Re: Montgomery/ Wyoming Apartments
4615 Wyoming Blvd. NE
Traffic Circulation Layout
Engineer's Stamp 11-08-22 (F19-D013C)

Based upon the information provided in your submittal received 11-16-22, the above referenced plan cannot be approved for Building Permit until the following comments are addressed:

DRAINAGE AND TRANSPORTATION INFORMATION SHEET

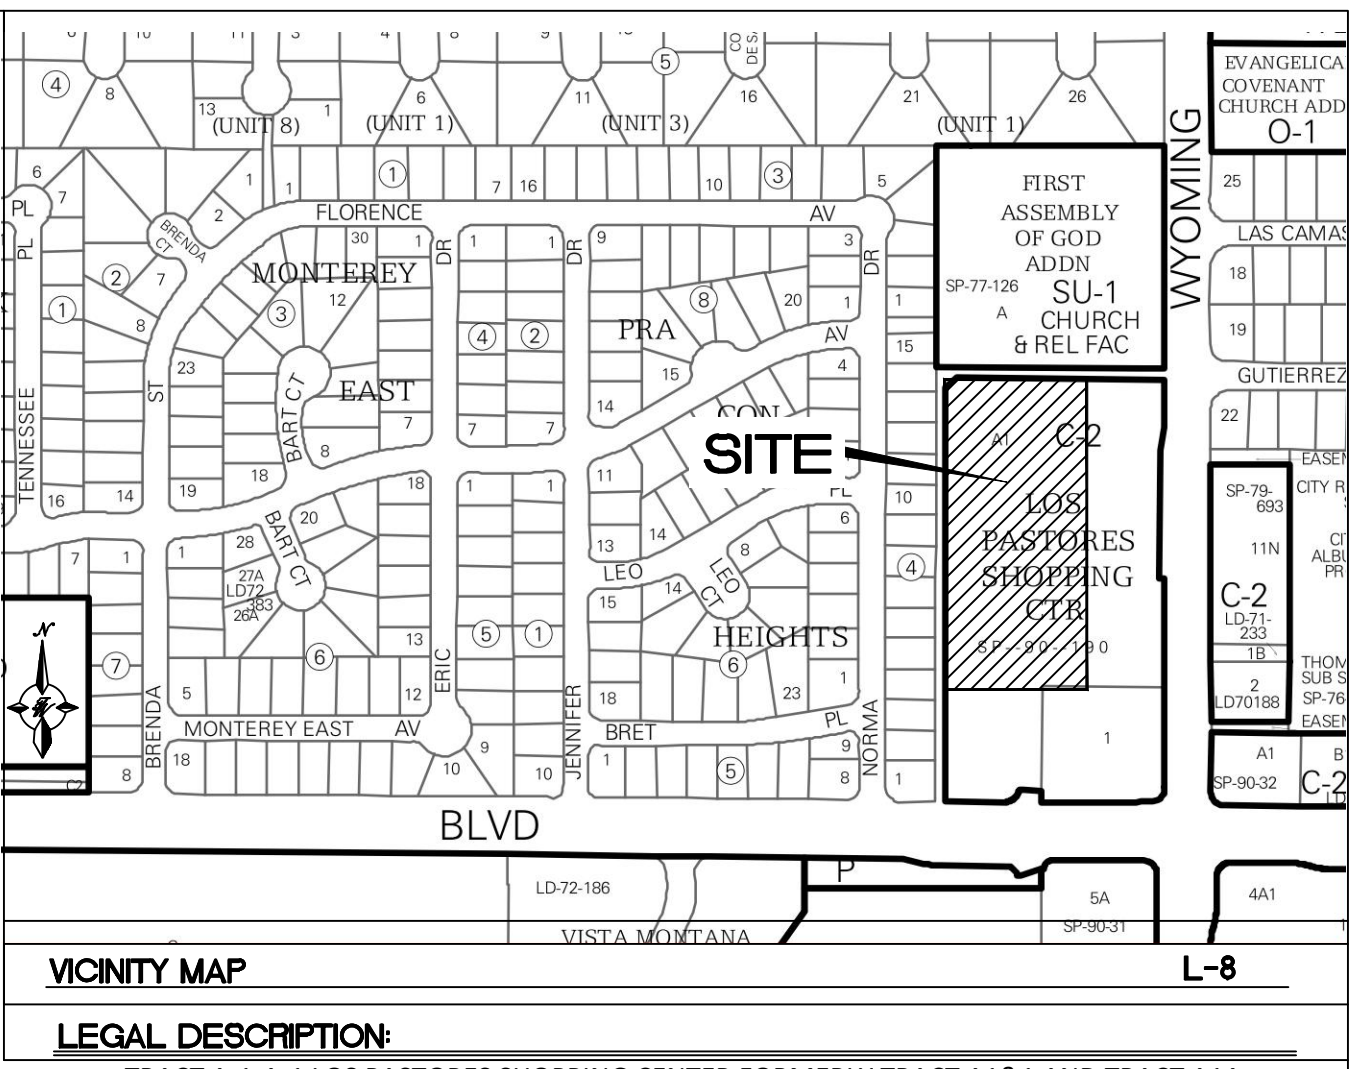
1. Identify all existing access easements and rights of way width dimensions.
2. Please provide shared access agreement, and approved plat.
3. Details sheet is missing.
4. Please list the width and length for all proposed parking spaces. Some dimensions are not shown.
5. The minimum parking stall dimensions are:

6. The ADA accessible spaces must include an access aisle. Van accessible aisles should be 8ft wide; all others should be 5ft wide.
7. The ADA accessible parking sign must have the required language per 66-7-352.4C NMSA 1978 **"Violators Are Subject to a Fine and/or Towing."** Please call out detail and location of signs.
8. ADA curb ramps must be updated to current standards and have truncated domes installed.
9. Key note 10: provide details for all the interior ADA ramps.
10. Due to proposing gates in the site, please provide vehicles turning template.
11. All bicycle racks shall be designed according to the following guidelines:

15. A 5 ft. keyway is required for dead-end parking aisles.
 16. Per the IDO, a 6 ft. wide ADA accessible pedestrian pathway is required from the public sidewalk to the building entrances. Please clearly show this pathway and provide details.

17. Per DPM, a 6 ft. wide ADA accessible pedestrian pathway is required from the ADA parking stall access aisles to the building entrances. Please clearly show this pathway and provide details.

18. Curbing should be installed to delineate landscape, parking, and pedestrian ways and identify points of access. Please call out detail and location of barrier curb.

19. Refuse vehicle maneuvering shall be contained on-site. The refuse vehicle shall not back into the public right of way. provide a copy of refuse approval.
